ARCHITECTURAL REVIEW BOARD STAFF REPORT

Project #/Name	ARB-2024-59: Community Christian Academy
Review Type	Major Amendment
Parcel Identification	06100-00-00-12700
Location	114 Old Brook Road (Figure 1)
Zoned	Residential (R2), Entrance Corridor (EC)
Owner/Applicant	Alliance Bible Church of Charlottesville et al, Trustees / Kelsey Schlein (Shimp Engineering)
Magisterial District	Rio
Proposal	To construct a modular classroom building behind the existing parsonage, and to undertake associated site improvements. The modular building would be located approximately 210' from the property line along Rio Road and 260' from the sidewalk.
Context	The site is located on the north side of Rio Road East, where there is a mix of commercial and residential structures ranging from small to medium/large in scale. Brick is a predominant material in the area.
Visibility	The modular classroom will have some limited visibility from the Entrance Corridor.
ARB Meeting Date	November 4, 2024

Figure 2: Concept Plan approved with SP-2024-16 (left) and proposed Site Development Plan (right)

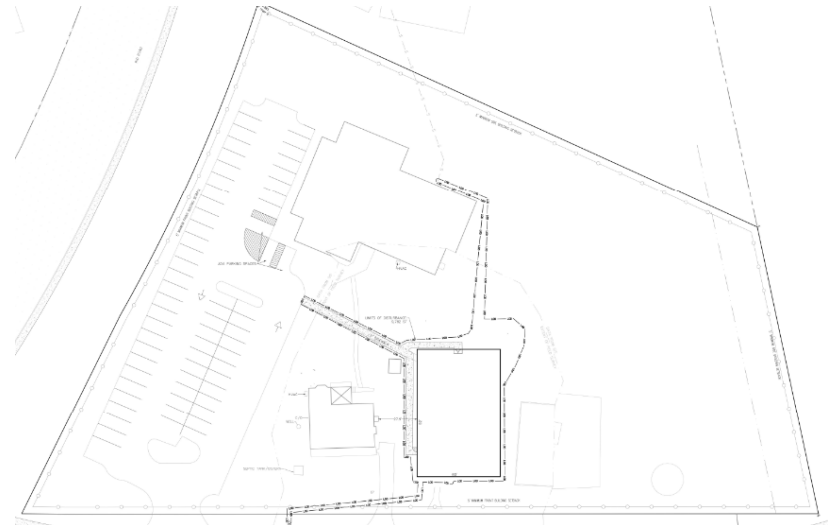
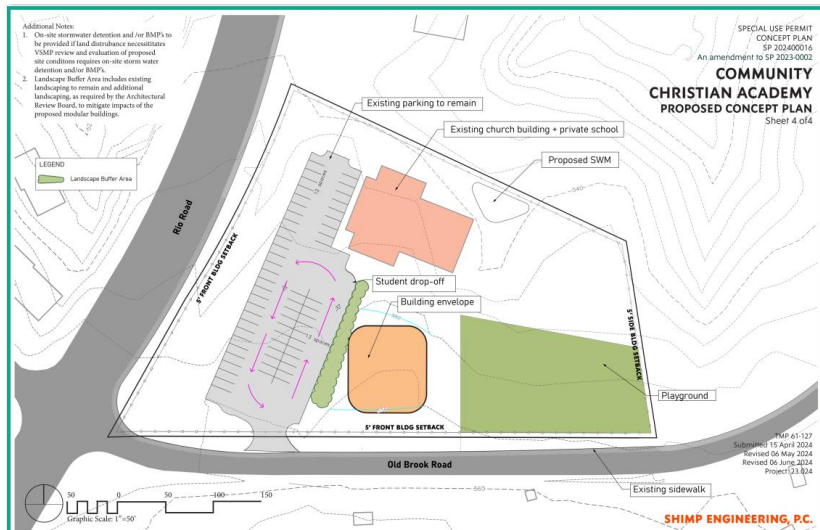
A Special Use Permit (SP) was approved on September 4, 2024, to add a modular classroom building to this site. ARB staff provided recommendations during the review of the SP, most of which focused on adding landscaping to mitigate the visual impacts of the structure. The approved concept plan (Figure 2) showed the modular building envelope in the general location of the existing parsonage, with a landscape buffer between the modular building and the parking lot. The Zoning Division has determined that the current proposal, which retains the parsonage and places the modular building to the east of that building, is consistent with the approved concept plan.

Figure 3: Landscape buffer location on approved Concept Plan (Left) and proposed landscaping with proposed Site Development Plan (Right).

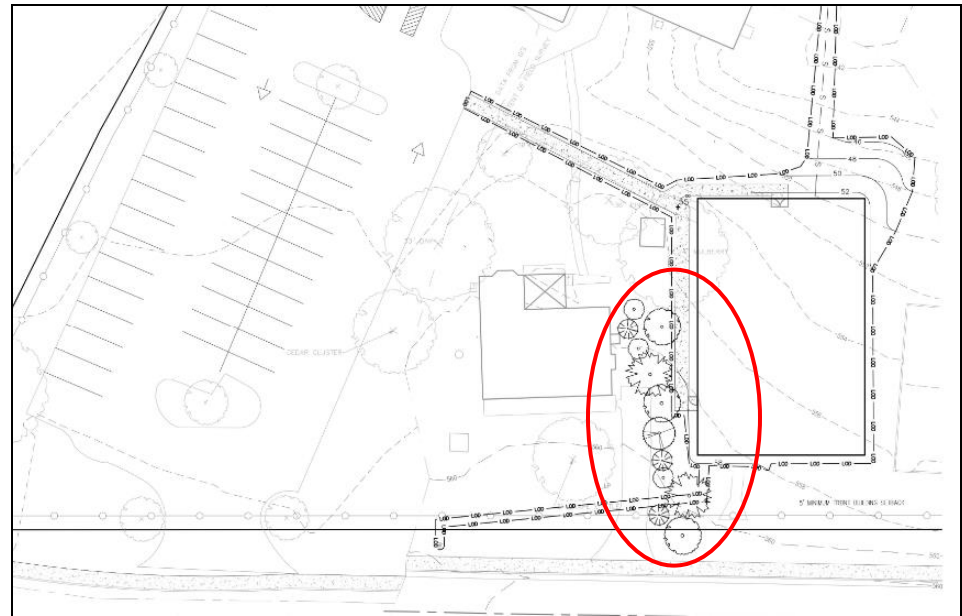
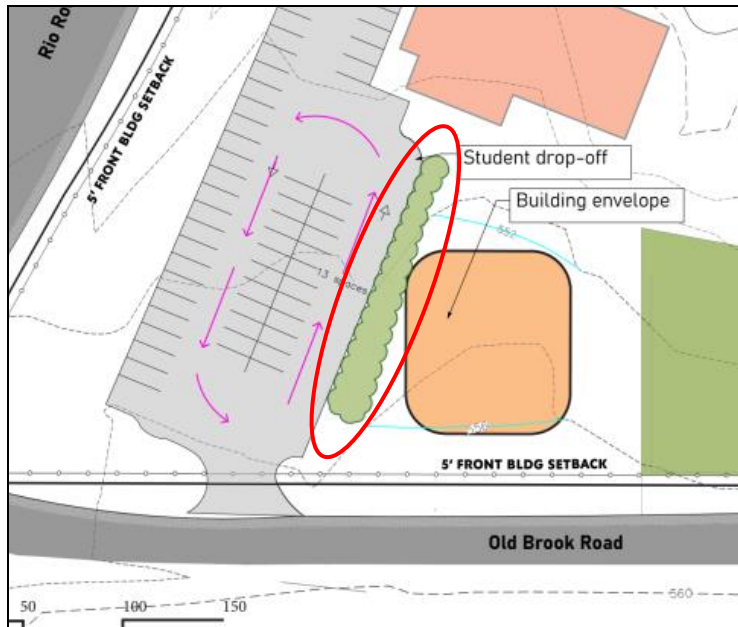
36	Landscaping of buildings and other structures: a. Trees or other vegetation should be planted along the front of long buildings as necessary to soften the appearance of exterior walls. The spacing, size, and type of such trees or vegetation should be determined by the length, height, and blankness of such walls. b. Shrubs should be used to integrate the site, buildings, and other structures; dumpsters, accessory buildings and structures; “drive thru” windows; service areas; and signs. Shrubs should measure at least 24 inches in height.	A mix of 2 large shade trees, 4 evergreen trees, 3 deciduous shrubs, and 3 evergreen shrubs are proposed between the parsonage and the modular building and along the east side of the driveway leading to the parsonage. The spacing of the plants is very close, some look cramped between the existing and proposed buildings, and one tree is shown off-site. Trees in this area could reduce the visibility of the modular building and its mechanical equipment, but the	Show all proposed landscaping on site. Revise the landscape plan to show evergreen trees near the modular building to screen HVAC equipment and large shade trees added at parking lot perimeters

cramped layout doesn't actively contribute to an orderly site layout or plant health. Limiting planting in this location to evergreens for screening HVAC equipment, and providing shade trees along parking perimeters could offset visual impacts of the modular building and contribute to an organized and integrated development along the corridor. A landscape buffer on the east parking lot perimeter is consistent with the approved concept plan. (Figure 3)	consistent with EC guidelines: large shade trees, 3½" caliper at planting, 35' on center; interspersed ornamentals; and shrubs, 24" in height at planting.
37	Plant species: a. Plant species required should be as approved by the Staff based upon but not limited to the <i>Generic Landscape Plan Recommended Species List</i> and <i>Native Plants for Virginia Landscapes (Appendix D)</i> .	The proposed plants are included in the County's plant list.	None.

11. Revise the landscape plan to show evergreen trees near the modular building to screen HVAC equipment and large shade trees added at parking lot perimeters consistent with EC guidelines: large shade trees, 3½” caliper at planting, 35’ on center; interspersed ornamentals; and shrubs, 24” in height at planting.
